**Re: Defect Information Report – Supplemental Report No. 8
10V-177 School Bus, 10V178 Non School Bus, FL-577
Hydraulic Brake Switches**

July 2011
FL577AB
NHTSA #10V-177 (School Bus)
NHTSA #10V-178 (Non-School Bus)
Transport Canada #10-130
REVISED NOTICE

Subject: Hydraulic Brake Switches

Models Affected: Specific Freightliner Custom Chassis B2 school bus chassis (Thomas Built Buses Saf-T-Liner C2), S2 shuttle bus chassis, MC motorhome chassis, and Freightliner Business Class M2 vehicles, manufactured between January 19, 2005, through May 5, 2010.

Fig. 1, Brake Switch Location, Fixed Brake Pedal

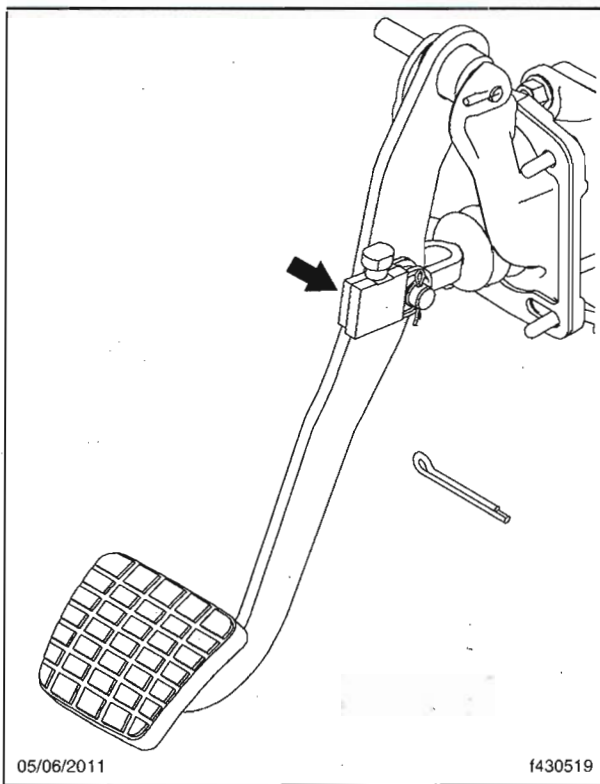
REVISIONS: Approximately 8,300 school buses have been added to the Recall as **FL577B**. Instructions for installing the hydraulic brake switch on adjustable pedals have been added to the Work Instructions. Fixed brake pedals will be inspected and replaced if necessary. Adjustable brake pedals do **not** require an inspection or replacement. The kits and SRTs remain the same.

If the brake pedal is a fixed version, go to the next step.

- Inspect the brake pedal for side-to-side play by moving the pedal from left to right. Measure travel at the brake pedal cover.

If the side-to-side play is *over 6 mm*, replace the brake pedal. Go to "Hydraulic Brake Pedal Replacement" in these Work Instructions.

If the side-to-side play is *6 mm or less*, do **not** replace the pedal. Go to the "Hydraulic Brake Light Switch Replacement" in these Work Instructions.

- Locate the brake switch on the brake pedal. See **Fig. 1** for location of the brake light switch on a fixed brake pedal. See **Fig. 2** for the location of the brake light switch on an adjustable brake pedal.
- Cut the tie strap on the harness leads going to the brake switch, and unplug the switch.
- Remove the cotter pin, flatwashers, clevis pin, and brake switch and discard all of the parts.
- Install the new clevis pin, flatwashers, brake switch, and hitch pin from the kit. Make certain one flatwasher is between the pushrod and the brake lever as shown in **Fig. 3**.

Fig. 4, New Brake Switch Installation (fixed pedal)

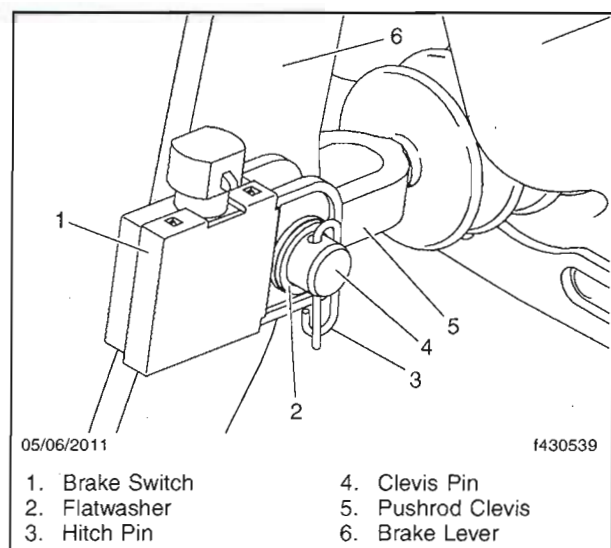
Make certain the other flatwasher is between the brake switch and the hitch pin, and that the hitch pin is installed as shown in **Fig. 4** for fixed brake pedal installations, or **Fig. 5** for adjustable brake pedal installations.

Fig. 6, Removing the Fixed Brake Pedal

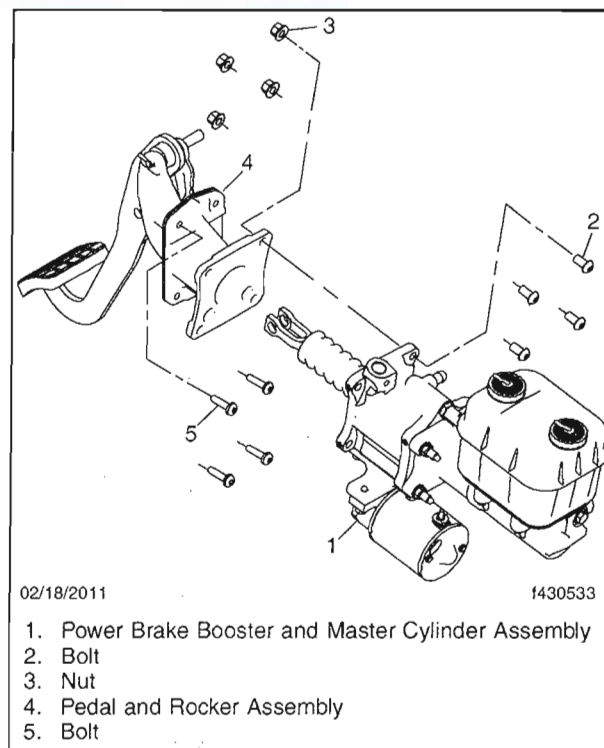
- Remove the cotter pin from the brake clevis and remove the clevis pin from the brake pedal. See **Fig. 6**.
- Disconnect the master cylinder from the brake cylinder and support the master cylinder by zip tying it to the engine. Be careful not to bend the hydraulic hard lines.

3. Remove the bolts holding the brake pedal to the frontwall, then pull the brake pedal through the frontwall.
4. Use the existing bolts and install the new brake pedal. Tighten the bolts 10 to 13 lbf-ft (14 to 18 N·m).
